From: Katie Jones [kjones@riceswd.com]
Sent: Monday, January 31, 2011 2:12 PM
To: Hansen, Edward J., EMNRD
Cc: Hack Conder; Katie Lee
Subject: Corrected Vacuum F-25 EOL (1R425-64) CAP Addendum
Attachments: Vacuum F-25 EOL (1R425-64) Proposed Liner - Plate 4.jpg

This email is an Addendum to the Vacuum F-25 EOL site (1R425-64) Corrective Action Plan, submitted to the NMOCD on November 24, 2010. Page 1, second paragraph: text in blue lettering, below, will be added to the paragraph. Red lettering marked with a strike-through will be deleted. The new plate 4 showing the proposed liner location is attached. If you need any further information, please let me or Hack know.

RE: Vacuum F-25 EOL
NMOCD Case #: 1R425-64
F-25 EOL, T17S, R35E, Section 25
Correction Action Plan

Plate 4

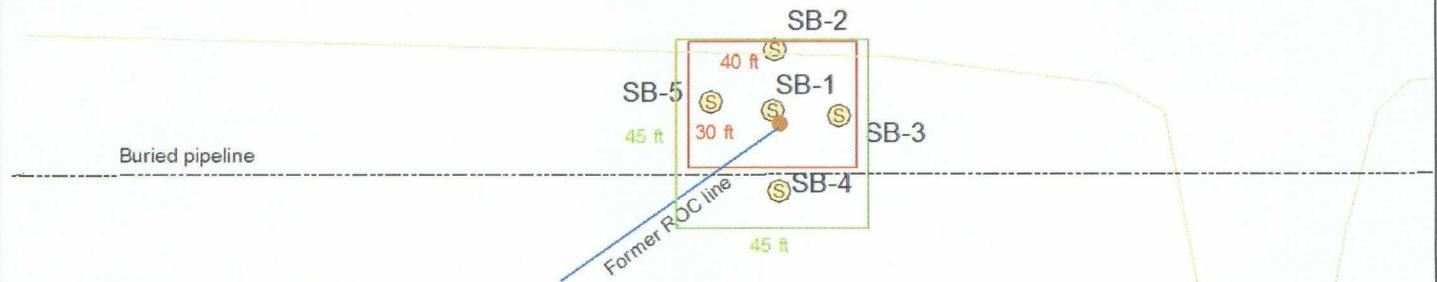
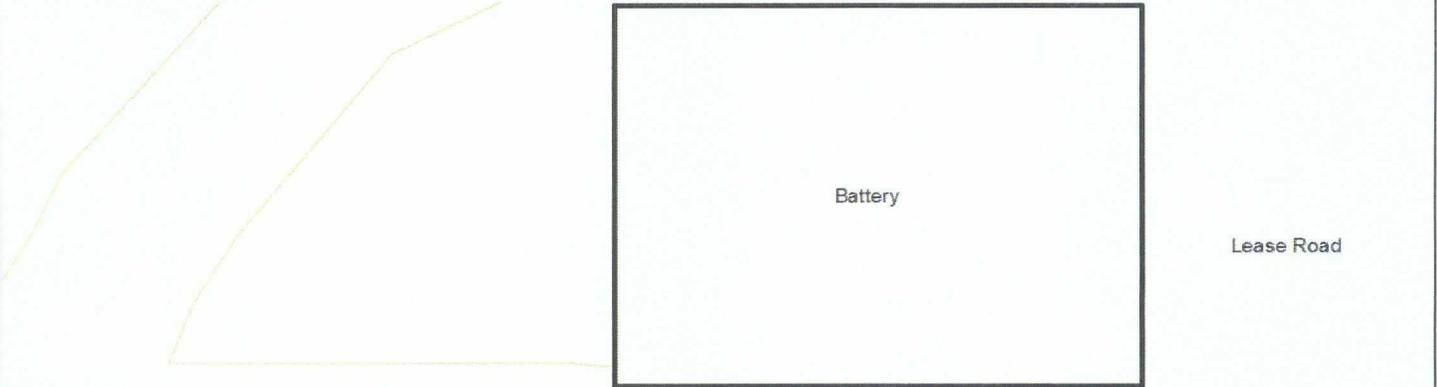
“Our recommended corrective action for the site is the installation of a 30 x 3040 foot synthetic liner 4-5 feet below ground surface centered over the former site and revegetation of an area 45 x 45 feet in size above the former site. This design meets the mandate of NMOCD Rules for protection of surface water, ground water and the environment. The investigation demonstrates that with this remedy in place residual chloride and hydrocarbons in the vadose zone will not with reasonable probability contaminate ground water or surface water in excess of the standards in Subsections B and C of 19.15.30.9 NMAC through leaching, percolation or other transport mechanisms, or as the water table elevation fluctuates.”

- Installation of a liner at a depth of four-feet underneath the 30-foot by 3040-foot area centered over the former site. Excavated soil will be evaluated for use as backfill above the liner. All backfill material will contain a chloride concentration below 500 mg/kg and PID (field parameter) reading less than 100 ppm. Any soil requiring disposal will be properly disposed of at an NMOCD-approved facility. ~~Clean fill (with a chloride concentration below 500 mg/kg and PID (field parameter) reading less than 100 ppm) will be imported to replace excavated material above the liner.~~
- Upon completion of the liner installation, re-vegetate a 45-foot by 45-foot area centered east-west over the former excavation and adjacent to the road on the north to reduce infiltration (see Plate 4).

“The remedy design for the site is the installation of a 30 x ~~30~~40 foot synthetic liner 4-5 feet below ground surface centered over the former site and re-vegetation of an area 45 x 45 feet in size above the former site. Our recommended corrective action meets the mandate of NMOCD Rules for protection of surface water, ground water and the environment. The investigation demonstrates that with this remedy in place, residual chloride and hydrocarbons in the vadose zone will not with reasonable probability contaminate ground water or surface water in excess of the standards in Subsections B and C of 19.15.30.9 NMAC through leaching, percolation or other transport mechanisms, or as the water table elevation fluctuates. Upon documentation of installation of the liner and re-seeding of the site with an appropriate mix of native grasses we will submit a Termination Request for this site’s regulatory file.”
